Co3197 – Colchester HES NH 5600(14) C/2 Re-Ad

ADDENDUM #3

Changes have been made to the documents located on the Bid Opportunity website as noted below:

PROJECT NAME: COLCHESTER	
PROJECT NUMBER: HES NH 5600(14) C/2 (Re-Ad)	
FILE NAME: gen_notes01.dgn	PLOT DATE: 4/2/2025
PROJECT LEADER: M. LACROIX	DRAWN BY: HSD
DESIGNED BY: B. TIETZE	CHECKED BY: HSD
GENERAL NOTES SHEET	SHEET 3 OF 405

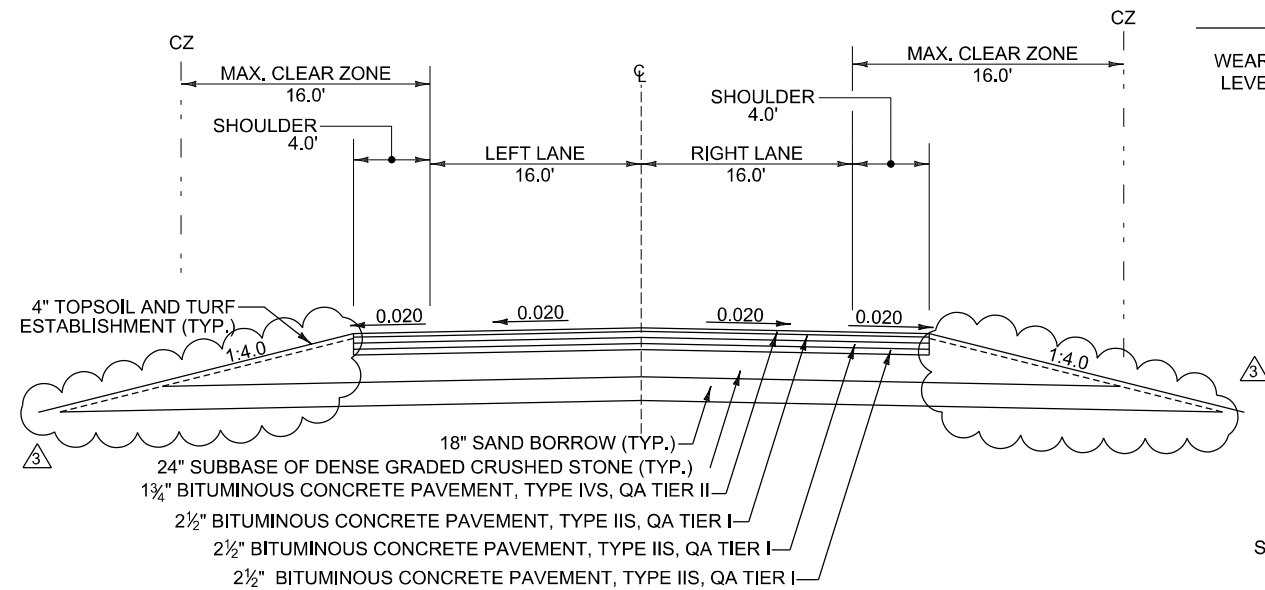
ADDENDUM	REVISION	PLOT DATE	DESCRIPTION	BY
3	1	31 MAR 2025	CHANGED LANGUAGE OF NOTE 9	BJT

PROJECT NAME: COLCHESTER
PROJECT NUMBER: HES NH 5600(I4) C/2 (Re-Ad)
FILE NAME: typ04.dgn
PROJECT LEADER: M. LACROIX
DESIGNED BY: B. TIETZE
TYPICAL SECTION SHEET 4
PLOT DATE: 4/2/2025
DRAWN BY: HSD
CHECKED BY: HSD
SHEET 8 OF 405

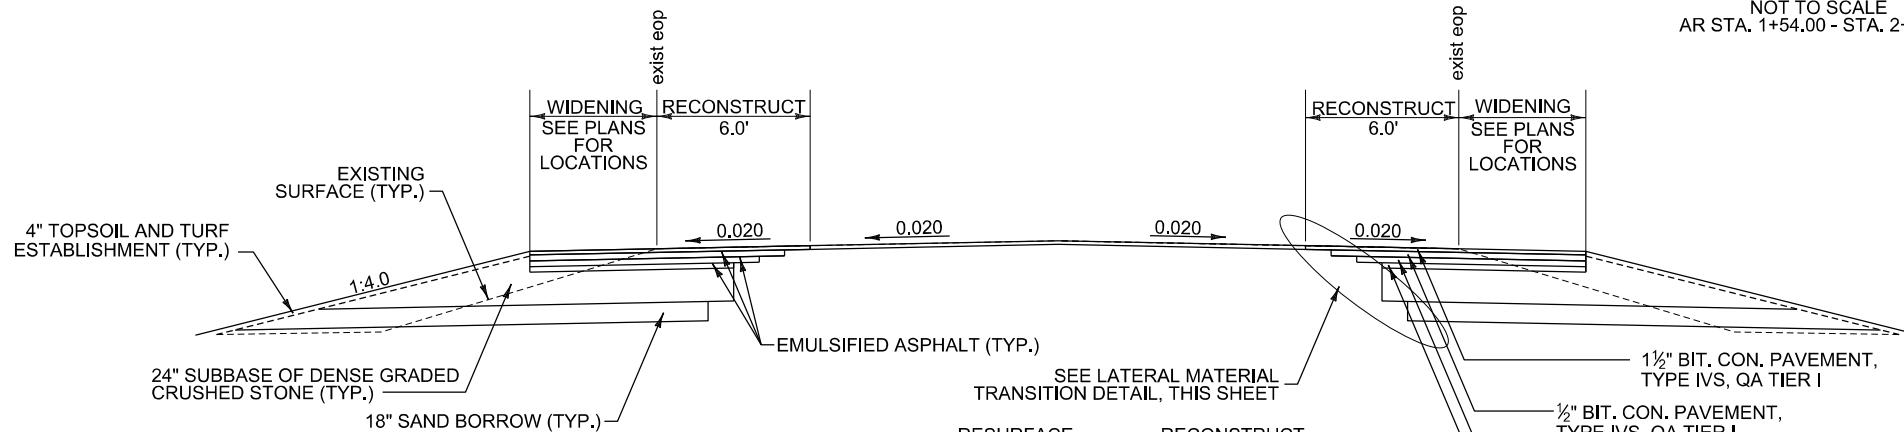
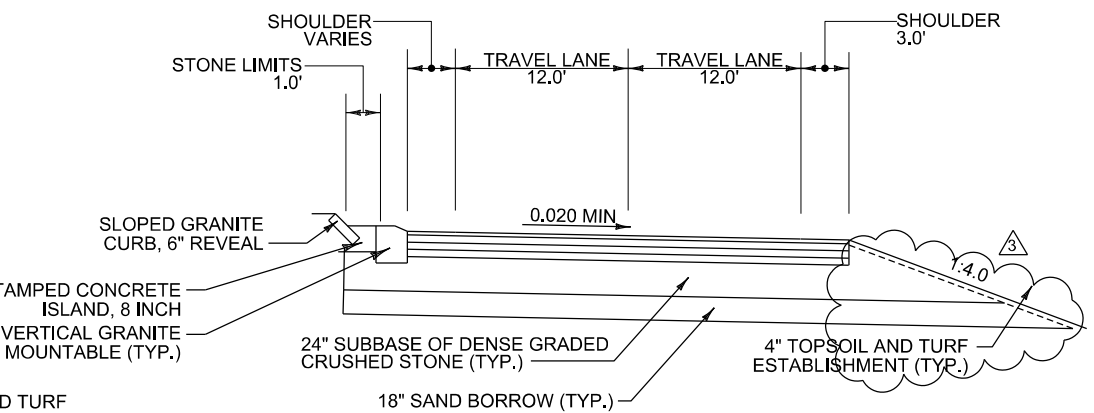
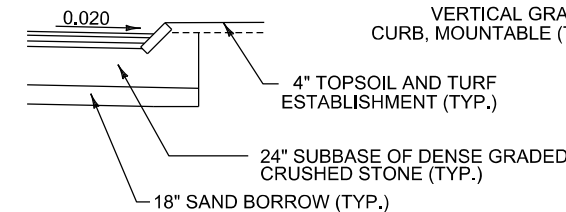
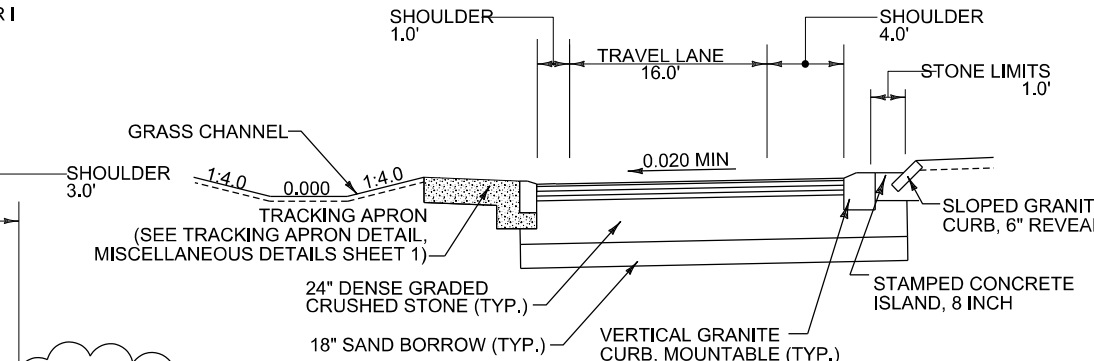
ADDENDUM	REVISION	PLOT DATE	DESCRIPTION	BY
3	1	31 MAR 2025	ADJUSTED SUBBASE LIMITS ON RAMP TYPICALS	BJT

PROJECT NAME: COLCHESTER
PROJECT NUMBER: HES NH 5600(I4) C/2 (Re-Ad)
FILE NAME: ms_det01.dgn
PROJECT LEADER: M. LACROIX
DESIGNED BY: B. TIETZE
MISCELLANEOUS DETAIL SHEET I
PLOT DATE: 4/2/2025
DRAWN BY: HSD
CHECKED BY: HSD
SHEET II OF 405

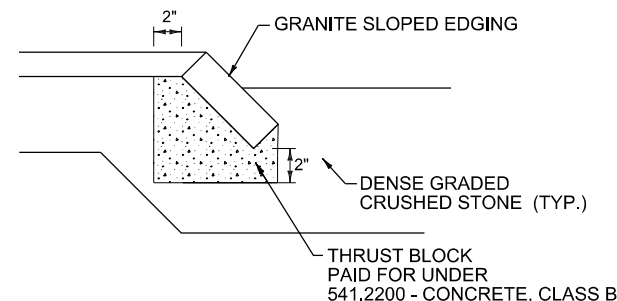
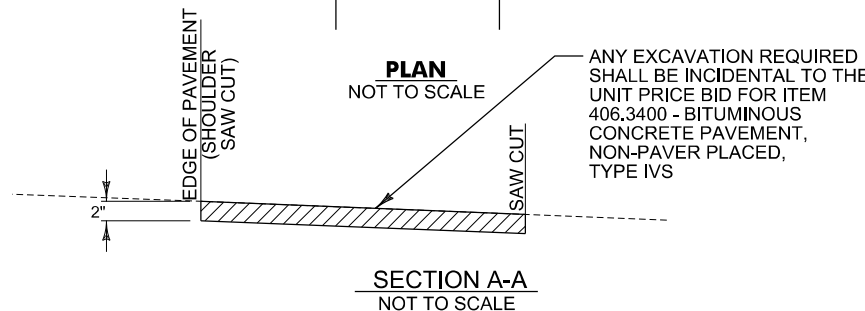
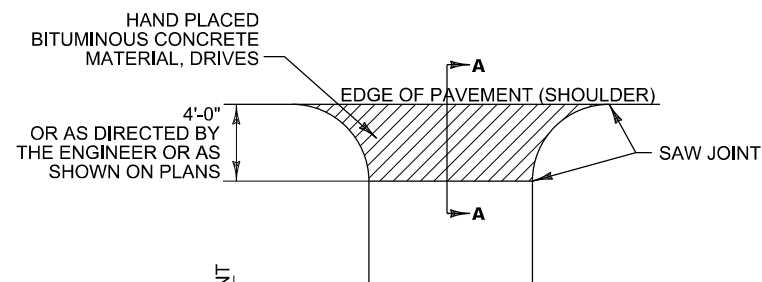
ADDENDUM	REVISION	PLOT DATE	DESCRIPTION	BY
3	1	31 MAR 2025	ADJUSTED THRUST BLOCKS TO MATCH DETAIL	BJT

PROJECT NAME: COLCHESTER
PROJECT NUMBER: HES NH 5600(I4) C/2 (Re-Ad)
FILE NAME: gen04.dgn
PROJECT LEADER: M. LACROIX
DESIGNED BY: B. TIETZE
GENERAL PLAN SHEET 4
PLOT DATE: 4/2/2025
DRAWN BY: HSD
CHECKED BY: HSD
SHEET 101 OF 405

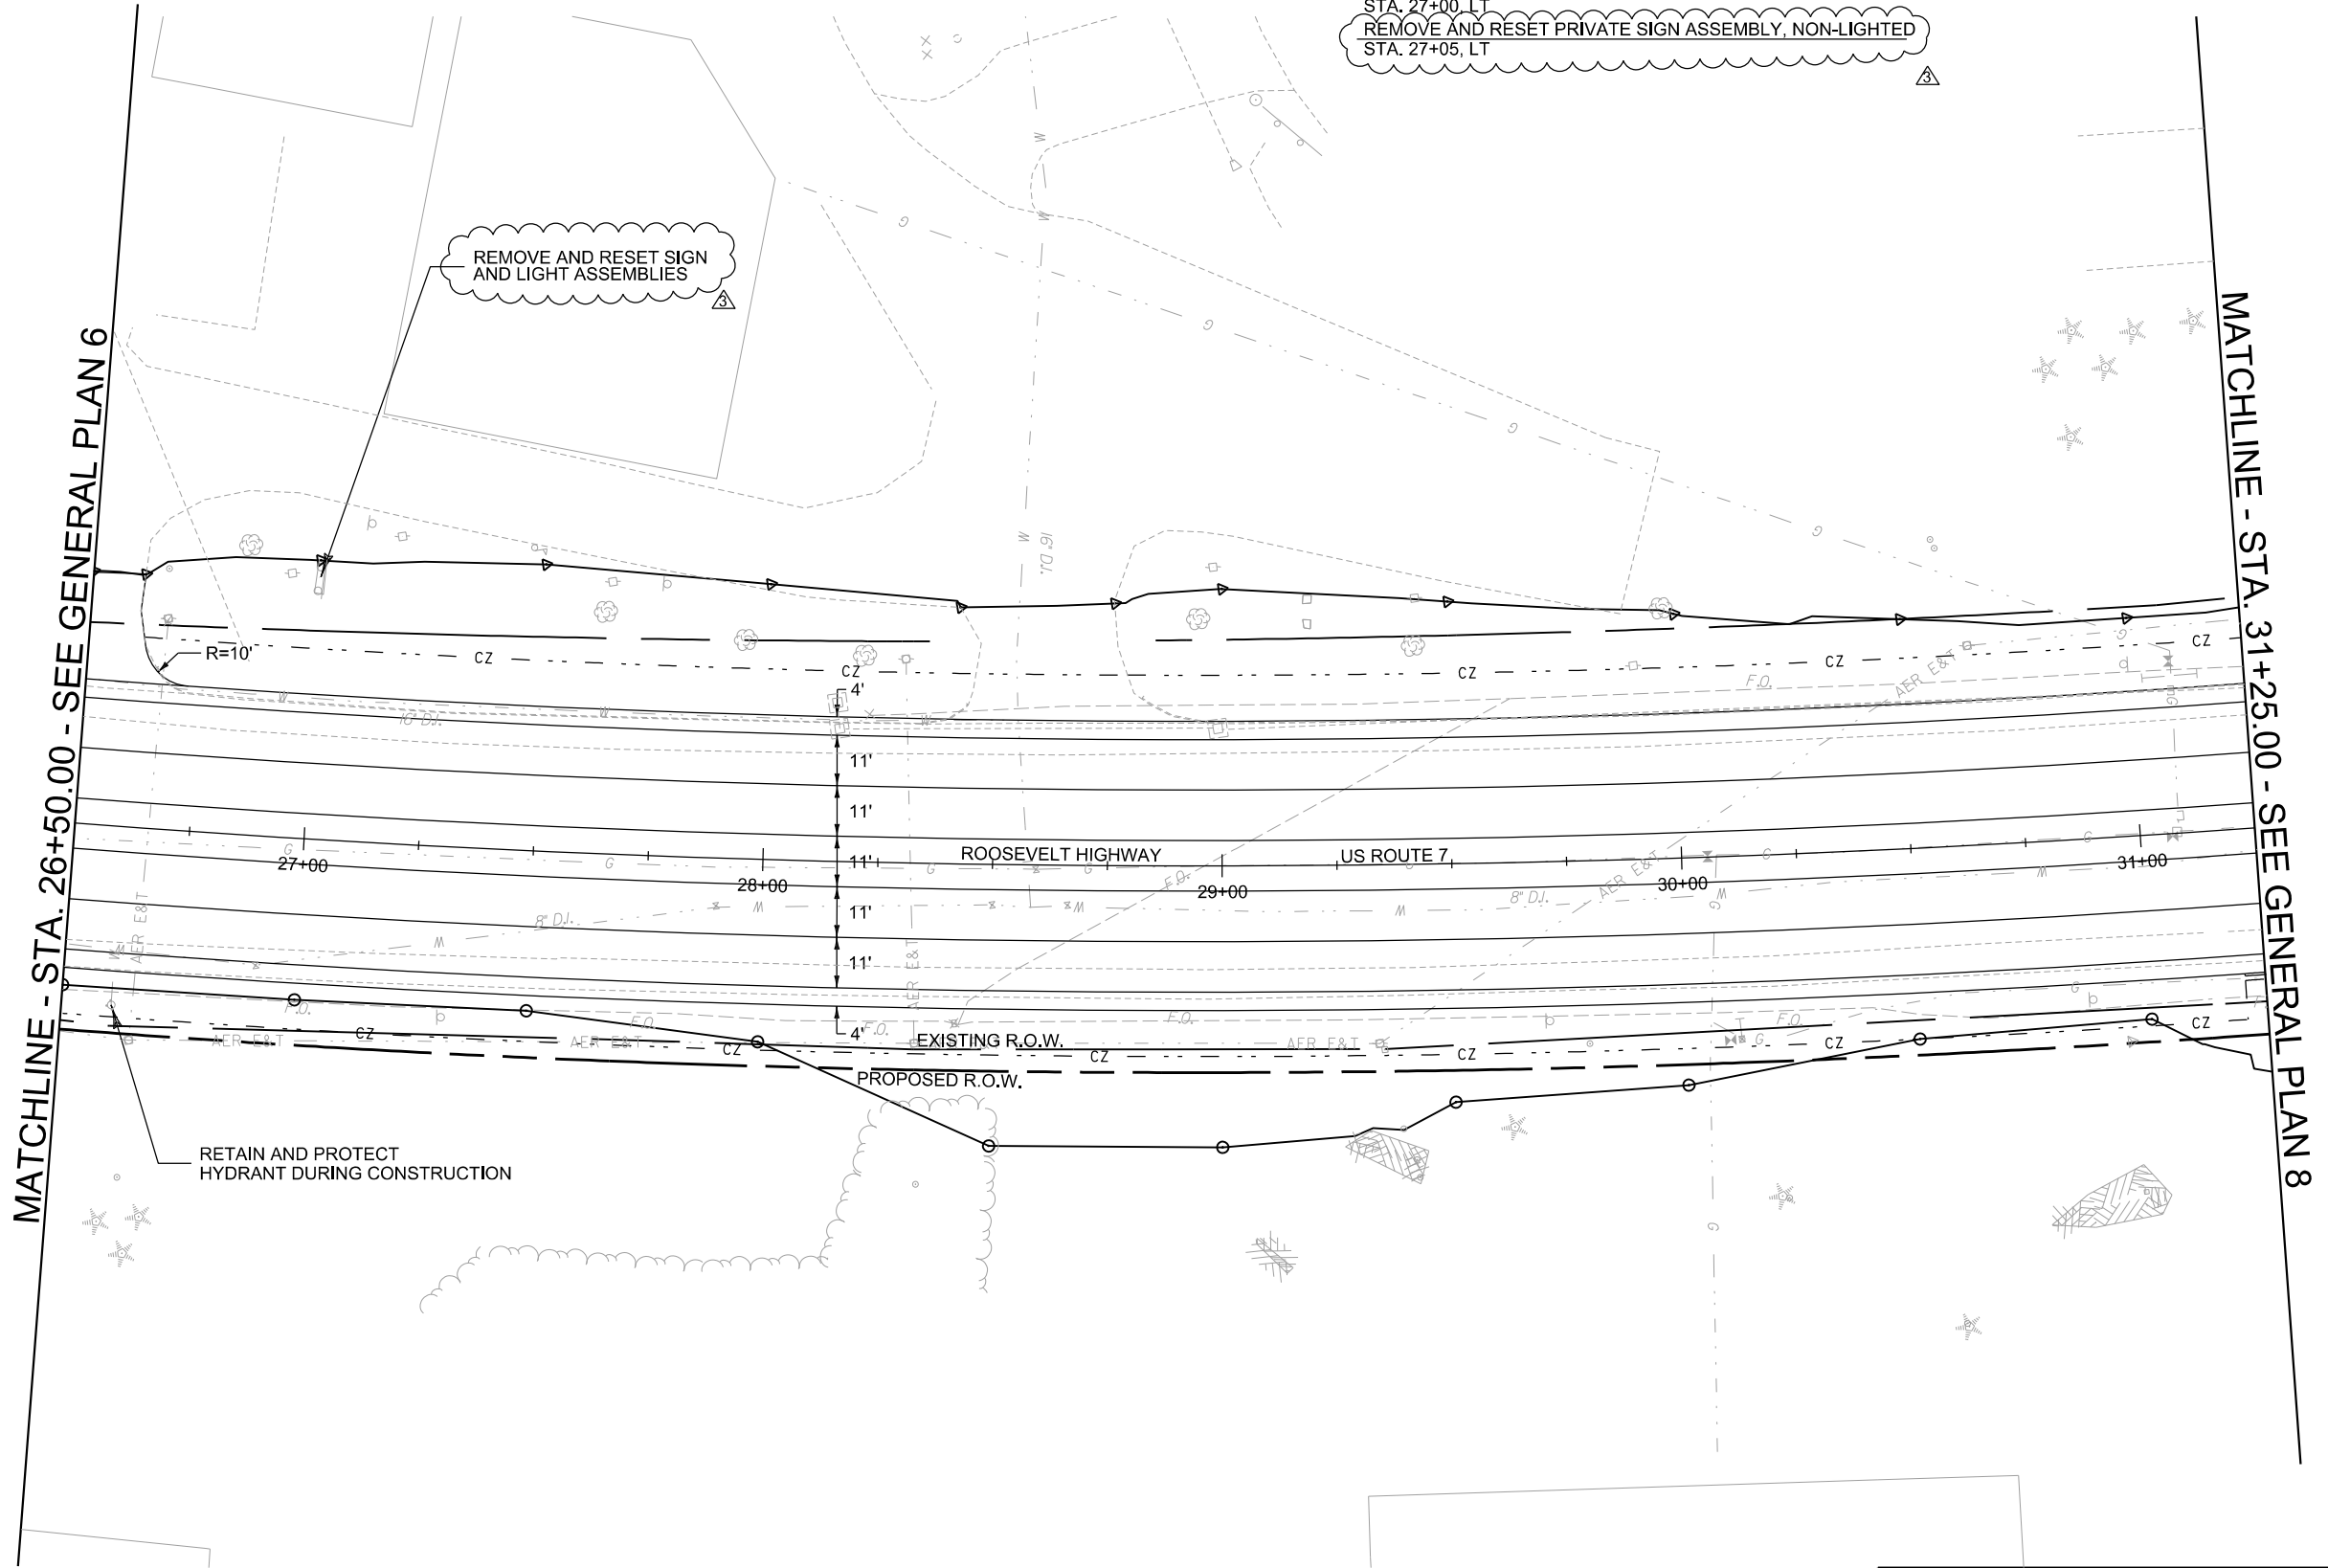
TEMPORARILY RELOCATE GROUND LIGHTS
PAID FOR UNDER CONTRACT ITEM 679.2600- REMOVE
AND RESET PRIVATE LIGHT ASSEMBLY
